CITY PLANNING COMMISSION

- APPLICATION:**
- A. Negative Declaration
 - B. Rezone 1+ vacant acre from Standard Single Family (R-1) to Multi-Family (R-2B; 2,000 sq. ft. unit)
 - C. Tentative Map (P87-341)
 - D. Special Permit to develop 21 apartment units on four lots and a common lot in the R-2B zone.

LOCATION: 2840 Taft Street

PROPOSAL: The applicant is requesting the necessary entitlements to develop 21 apartment units on four lots and a common lot in the R-2B zone.

FRONT ELEVATIONS

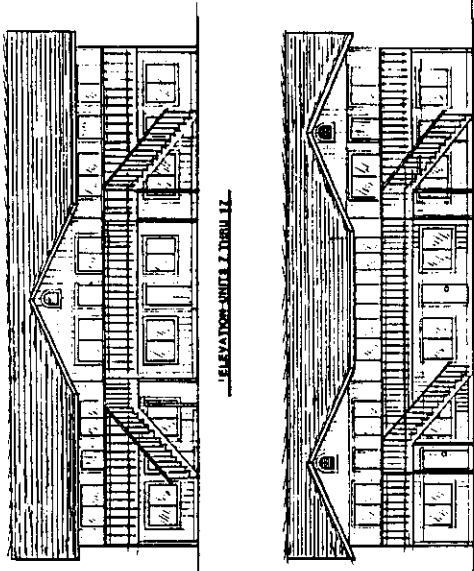
There are two different elevations for the six unit structures. One unit has two front gables and the other has one front gable. Staff suggests that more interest would be provided if the two-gable structure were used twice, therefore, the end building, units 13 through 18, should be of the double gable elevation as well as the front building units, 1 through 6.

End elevations have small paned windows. This treatment should be carried to the front elevations.

Staff also suggests that front roof overhangs be extended flush with the outside of the stairway for both elevations.

1. The double-gable elevations shall be used for units 1-6 and 13-18.
2. Roofing material shall be shake shingles.
3. The roof overhang for the front elevations shall extend out flush with the stairway handrail.
4. Stairways, handrails and verticals shall be of wood.
5. Stairways shall be double-stringer.
6. Small paned windows shall be used on the front and end elevations.
7. Detailed landscaping and irrigation plans shall be approved by staff prior to issuance of building permits; these plans shall include trees planted along the north property line to soften the appearance of the rear elevation.
8. Trash enclosures shall comply with zoning ordinance requirements.
9. Detailed carport plans indicating the use of similar design and building material shall be reviewed and approved by staff prior to issuance of building permits. A wood fascia shall be utilized.

REAR ELEVATION UNITS 1 THRU 6

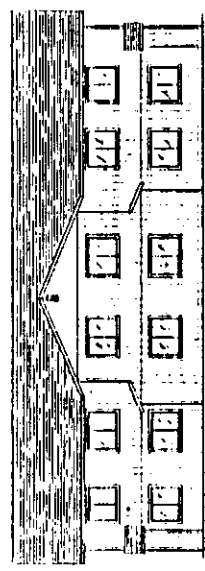
To break up the rear elevation, staff suggests trees be planted along the northern property line. Detailed landscaping and irrigation plans shall be approved by staff prior to issuance of building permits.
